Access Compliance Report

Public Rights-of-Way

Intersection ID: 22219	Main Street: PARK_RD	Cross Street: SETH_THOMAS_RD	Location: NW
ADA ID: BA443CCEA3AE	Ramp Type: PerpDiag	Initial Pass/Fail: Fail	Overall Compliance: No
		Severity Score: 25

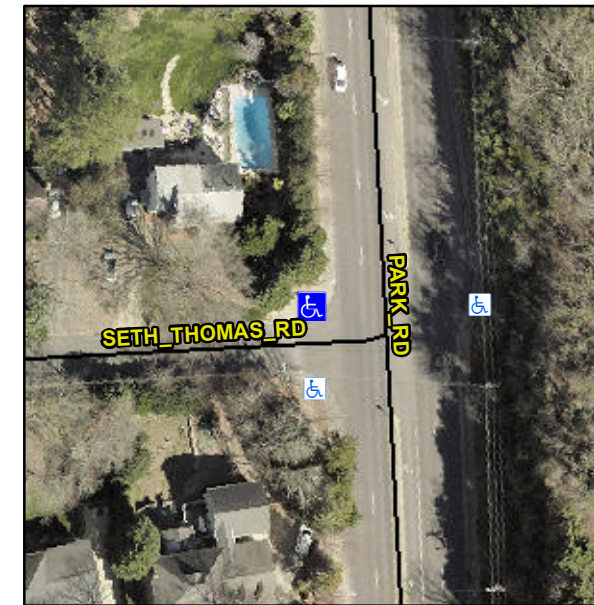
Not Found, R304.2.2, R304.5.3

Compliance	Description	Data	Compliance	Description	Data
N/A	Ramp Length (in)	61.0	No	Ramp Slope (%)	9.6
Yes	Ramp Width (in)	48.0	No	Ramp XSlope (%)	5.2
N/A	Flare Type LT	N/A	N/A	Flare Type RT	N/A
N/A	Flare Slope LT (%)	N/A	N/A	Flare Slope RT (%)	N/A
N/A	Flare Traversable LT?	N/A	N/A	Flare Traversable RT?	N/A
N/A	Landing Length (in)	N/A	N/A	DWS Provided?	N/A
N/A	Landing Width (in)	N/A	N/A	DWS Contrast?	N/A
N/A	Landing Slope (%)	N/A	N/A	DWS Length (in)	N/A
N/A	Landing X Slope (%)	N/A	N/A	DWS Full Width?	N/A
N/A	Landing Curb? (Y/N)	N/A	N/A	DWS Offset (in)	N/A
N/A	Shared Landing?	N/A			
N/A	Gutter Ponding?	N/A	N/A	Gutter Slope (%)	N/A
N/A	Gutter Lip Ht (in)	N/A	N/A	Gutter X Slope (%)	N/A
N/A	Painted X Walk1?	No	N/A	Painted X Walk2?	No
	X Walk 1 Direction	To S		X Walk 2 Direction	To E
N/A	X Walk 1 Width (in)	N/A	N/A	X Walk 2 Width (in)	N/A
	X Walk 1 Slope (%)	2.1		X Walk 2 Slope (%)	10.5
	X Walk 1 X Slope (%)	8.7		X Walk 2 X Slope (%)	1.0

Remove & Replace Curb Ramp With Two New Directional Ramps or Equivalent.
